<p>RETURN BIDS TO: RETOURNER LES SOUMISSIONS À:</p> <p>Bid Receiving - Environment Canada / Réception des soumissions – Environnement Canada</p> <p>Electronic Copy: ec.soumissions-bids.ec@canada.ca</p> <p>BID SOLICITATION AMENDMENT MODIFICATION DE LA DEMANDE DE SOUMISSIONS</p> <p>The referenced Bid Solicitation is revised in this document; unless otherwise indicated, all other terms and conditions of the Bid Solicitation remain the same.</p> <p>La demande de soumissions citée en référence est modifiée dans ce document; sauf indication contraire, les modalités de la demande de soumissions demeurent les mêmes.</p>	Title – Titre	
	Electrical Installation at the Marble Mountain Radar Site	
	EC Bid Solicitation No./SAP PR No. - N° de la demande de soumissions EC / N° SAP PR 5000061263	Amendment No. - N° de modif. 001
	Date of Bid Solicitation (YYYY-MM-DD) – Date de la demande de soumissions (AAAA-MM-JJ) 2021-09-08

The bid solicitation is amended as follows:

ADDENDUM: Ref Drawing E6.1, Section A. :

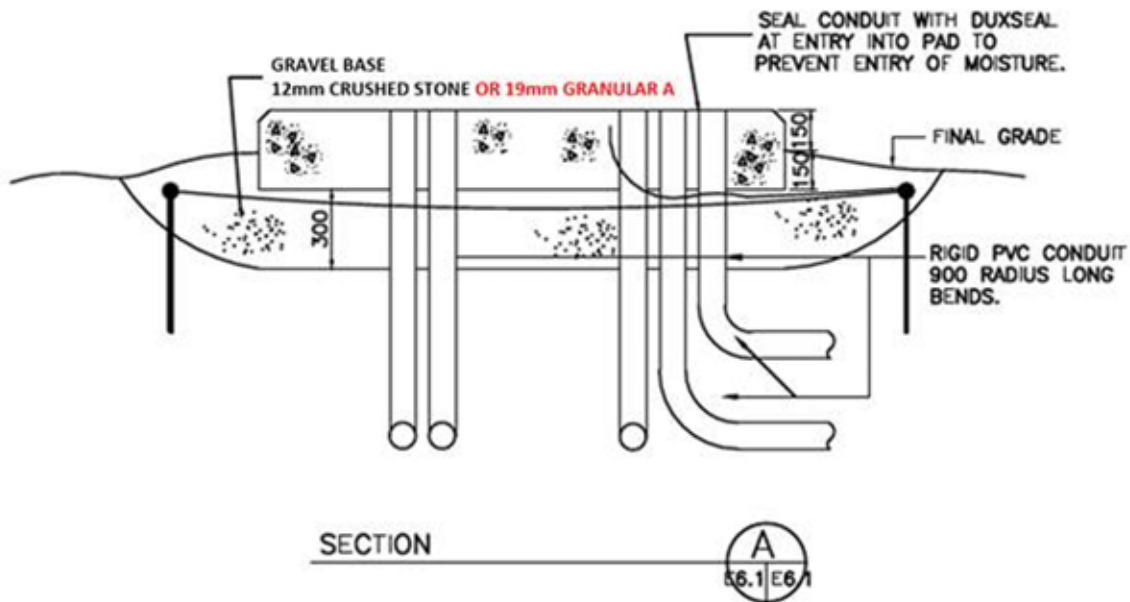
Delete:

Insert:

Q10. Drawing E6.1, Section A calls for 12mm crushed stone, this is not a common size. Can this 12mm stone be substituted for 19mm stone (Class A) which is common and readily available in the area of the work?

A10. Yes, 19mm is acceptable
